UNITED STATES PATENT AND TRADEMARK OFFICE

APPLICATION NO.	FILING DATE	FIRST NAMED INVENTOR	ATTORNEY DOCKET NO.	CONFIRMATION NO.
10/500,583	06/29/2004	Jan Webjorn	P/4447-3 PCT	5248
2352	7590	06/13/2006	EXAMINER	
OSTROLENK FABER GERB & SOFFEN 1180 AVENUE OF THE AMERICAS NEW YORK, NY 100368403			AMIRI, NAHID	
			ART UNIT	PAPER NUMBER
			3679

Office Action Summary	Application No. 10/500,583	Applicant(s) WEBJORN, JAN	
	Examiner Nahid Amiri	Art Unit 3679

DETAILED ACTION

A. J. DEL BUONO
BALANCED FACE FLANGE

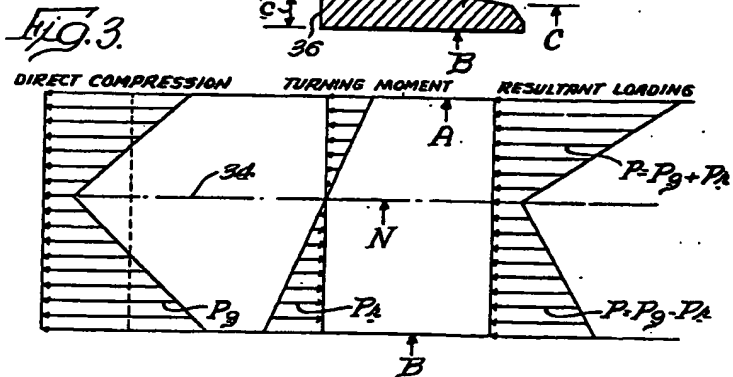
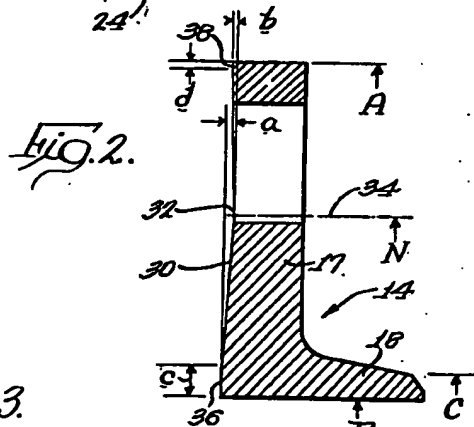
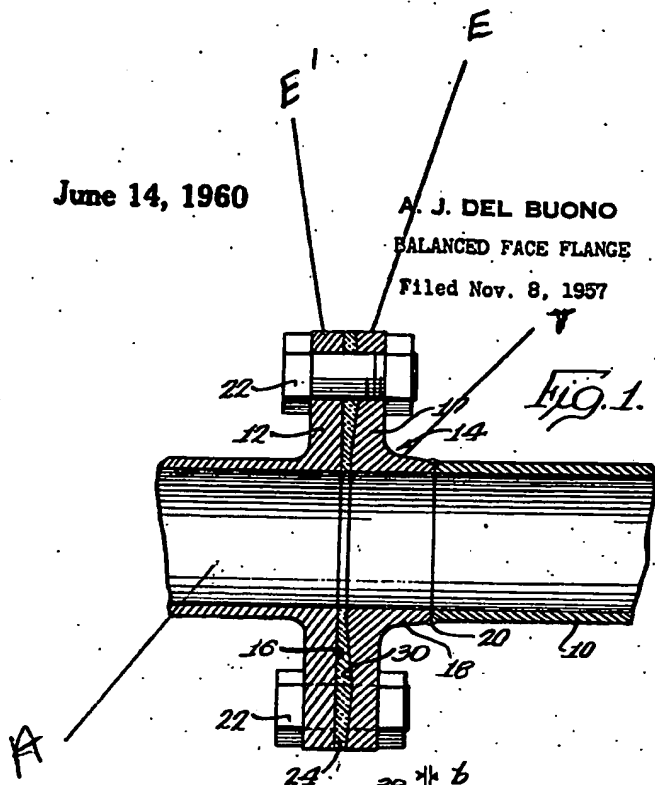
With respect to claim 1, Buono discloses a flanged member (14, Figs. 1-3) intended to included as a first component in a flange comprising a first component (14) in a flanged joint

having a first flanged end (E) with a first end surface (30) intended to be assembled together with a corresponding end surface (16) of a flanged end (E', see attachment) on another, a second flanged member (12) in the flanged joint, the first end surface (30) of the first flange (14) is concave which formed from multi-straight lines, wherein in unstressed condition is slightly concave in the radial direction over at least a part of the extension thereof in the radial direction; and wherein in an unstressed condition, the first end surface (30) is inclined in the radial direction, outward and away from a conceived opposite end surface of the second component (12). Buono does not disclose the concave of the first end surface is curved. It would have been obvious to one of ordinary skill in the art at the time of invention was made to form the concave of the first end surface as a curve instead of forming it from multi-straight lines, since it has been held that omission of an element and its function in a combination where the remaining elements perform the same function as before involves only routine skill in the art. In re Karlson, 136 USPQ 184.

With respect to claim 2, Buono discloses (Figs. 1-3) wherein the first end surface (30) is concave over the entire extension thereof in the radial direction.

With respect to claim 3, Buono discloses (Figs. 1-3) wherein the first end surface (30) is concave in the radial direction over at least an area that will be subjected to deforming forces when the flanged member (14) is assembled together with another flanged member (14 as well as during use.

With respect to claim 4, Buono discloses (Figs. 1-3) wherein the first end surface (30) is concave in the radial direction over essentially that area which, during use, constitutes a contact surface against the corresponding end surface (16) of the second flanged member (12).

With respect to claims 5 and 14, Buono discloses (Figs. 1-3) wherein the first end surface (30) comprises more than one concave part surface in the radial direction; and wherein the part surface has different radii of curvature.

With respect to claim 6, Buono discloses (Figs. 1-3) that further comprising an internal through axial opening (A) (see attachment), the first end surfaces (30) having an innermost

abutment point against the corresponding end surface (16) of the second flanged member (12), which abutment point is situated farthest in the radial direction at the opening (A), the concavity of the first end surface (30) extending all the way in to the abutment point.

With respect to claim 7, Buono discloses (Figs. 1-3) wherein the first end surface (30) has an innermost abutment point against the corresponding end surface (16) of the second flanged member (12), which has an internal through axial opening (A), the innermost abutment point being situated farthest in the radial direction, at the opening (A), the concavity of the first end surface (30) extending all the way in to the abutment point.

With respect to claim 10, Buono discloses (Fig. 1) wherein at least a part of a transition area (T) (see attachment), between the surface of the flange directed away from the end surface (30) and a part of the flanged member that is substantially parallel to a longitudinal axis of the member, is shaped as a substantially elliptical area.

With respect to claim 11, Buono discloses a Joint (Figs. 1-3) comprising two joint halves formed as two flanged members (12, 14) and included in a pressure equipment device, the members (12, 14) have at least one flanged end (E, E') each having an end surface (30, 16), and the flanged members (12, 14) are assembled together via the end surfaces (16, 30) of the flanged ends (E, E'), the end surfaces (16, 30) are facing each other, the end surface (30) of at least one of the flanged members (14) being slightly concave in a radial direction over at least a part of an extension thereof in the radial direction when the end surface is in an unstressed condition.

With respect to claim 12, Buono discloses (Figs. 1-3) wherein both of the flanged members (12, 14) have a concave end surface.

With respect to claim 13, Buono discloses (Figs. 1-3) wherein the end surfaces (30, 16) facing each other are inclined in the radial direction outwards so that they, in radial cross-section, form an angle to each other, when they have been brought together but before assembly, which angle is such that a distance between the two end surfaces (30, 16) increases in the radial direction outwards, at least one of said inclined end surfaces being slightly concave.
